AMENDMENT LETTER

AVIFAUNAL SPECIALIST INPUT: PROPOSED AMENDMENTS TO THE EA AND FINAL LAYOUT OF THE BEAUFORT WEST SOLAR PV ENERGY FACILITY (SEF) NEAR BEAUFORT WEST IN THE WESTERN CAPE PROVINCE

Figure 3: Proposed Amended Final Layout (Preferred) of the Beaufort West SEF. Avifaunal sensitivities indicated in red.

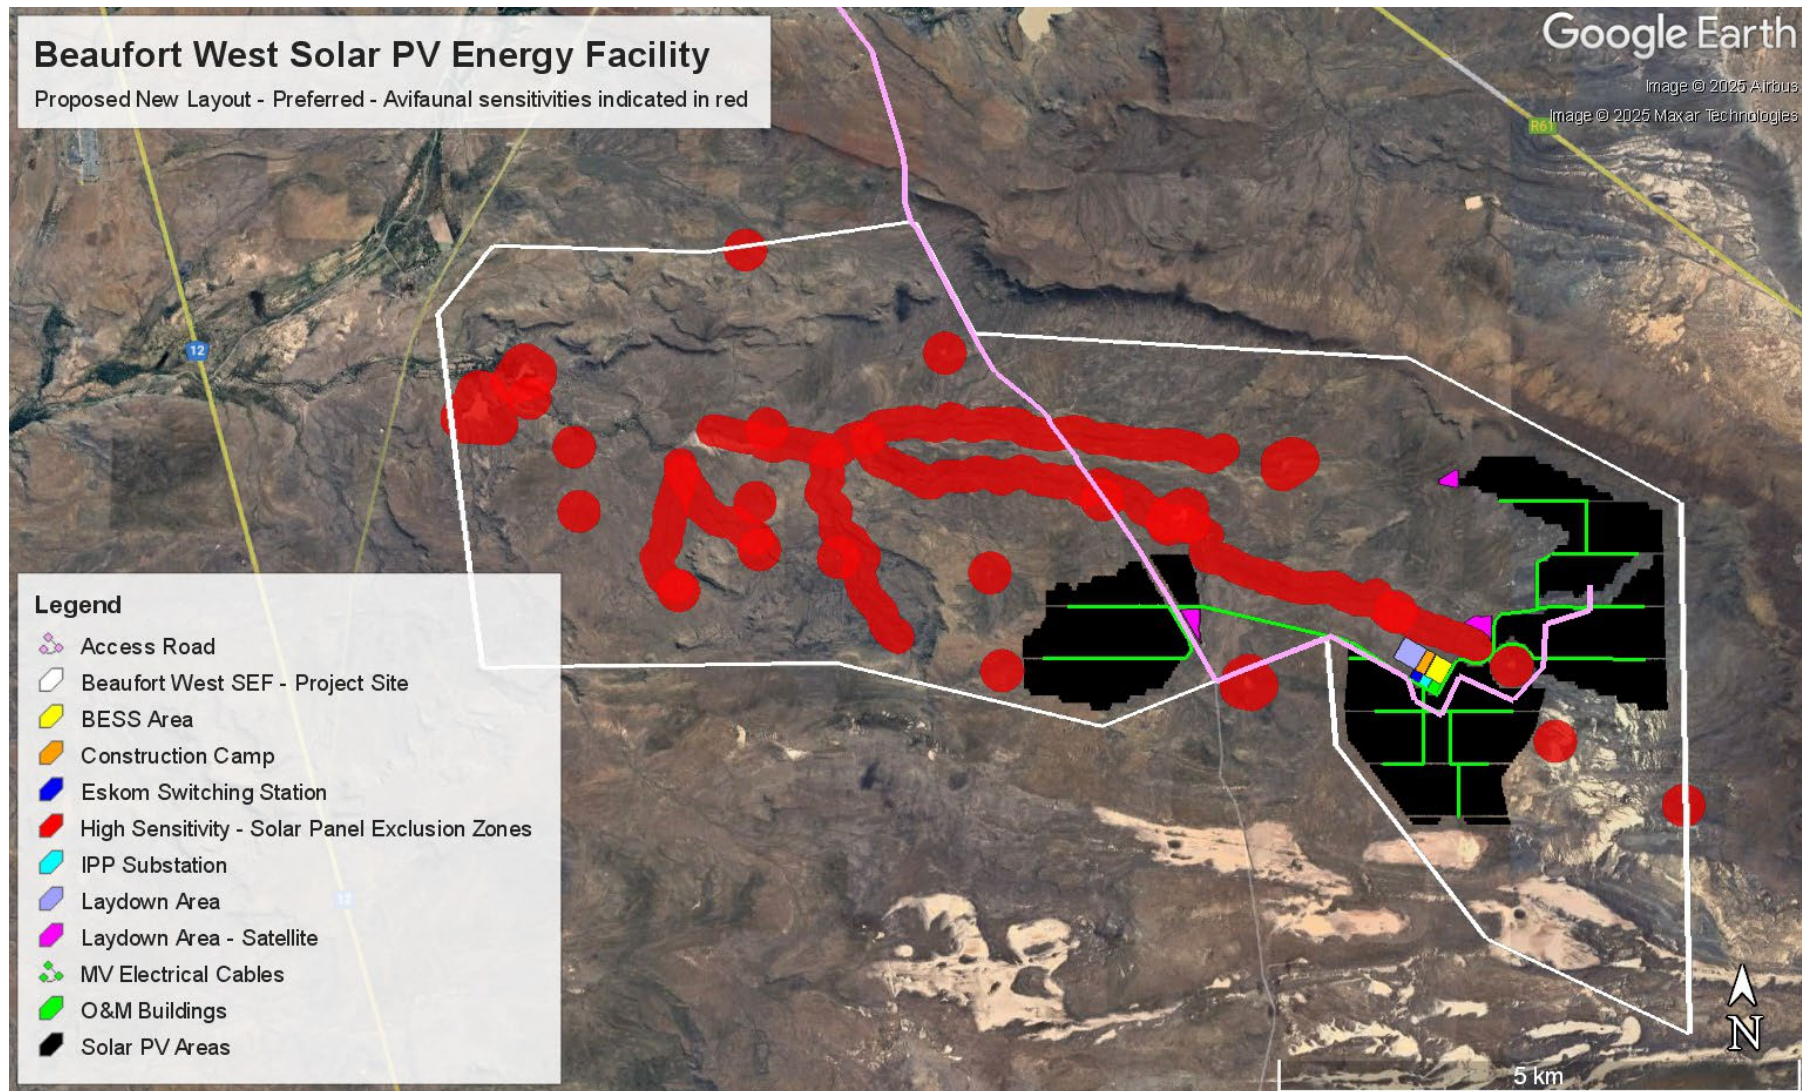
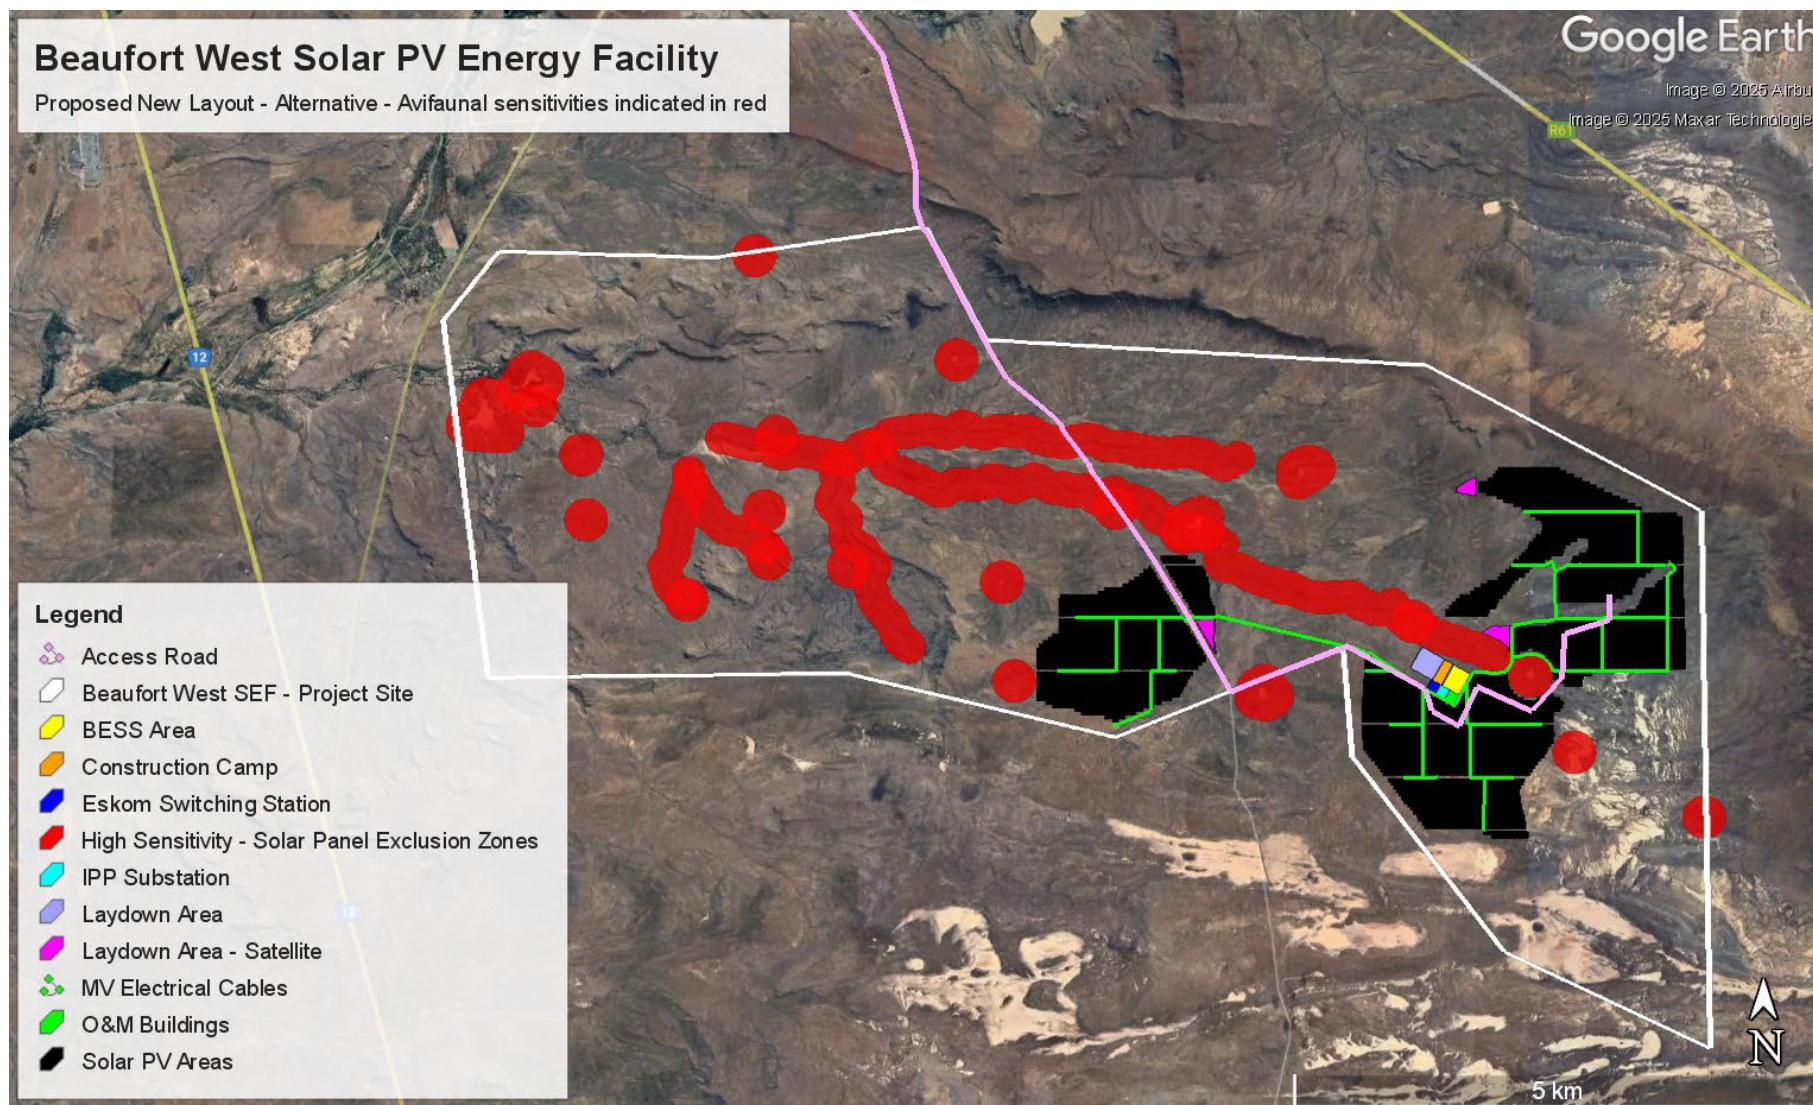
The proposed amended layout plans (the preferred layout and alternative layout) have both taken the identified avifaunal sensitives into account (**Figures 3 & 4**). The proposed amendments to the layout plan (preferred and alternative) will not result in an increased level or change in the nature of the avifaunal impacts originally identified or require any changes to the mitigation measures recommended in the Avifaunal Impact Assessment (Chris van Rooyen Consulting 2022). The inputs into the final EMP_r for the SEF should be as per the original recommendations, which is included in Section 7 below for ease of reference. The proposed changes to the Layout Plan would not result in any changes to the impact management outcomes (with respect to avifauna) of the EMP_r. **Overall, the proposed amended final layout plans (the preferred layout and alternative layout) is considered acceptable from an avifaunal impact perspective, provided all mitigation measures are strictly implemented.**

- A 200m solar panel exclusion zone must be implemented around dams, wetlands, and any other sources of open water, and a 150m solar panel exclusion zone must be implemented around drainage lines, as indicated and taken into account in the layouts in **Figures 3 and 4**.
- Construction activity should be restricted to the immediate footprint of the infrastructure and laydown areas, as per the proposed layout.
- Measures to control noise and dust should be applied according to current best practice in the industry.
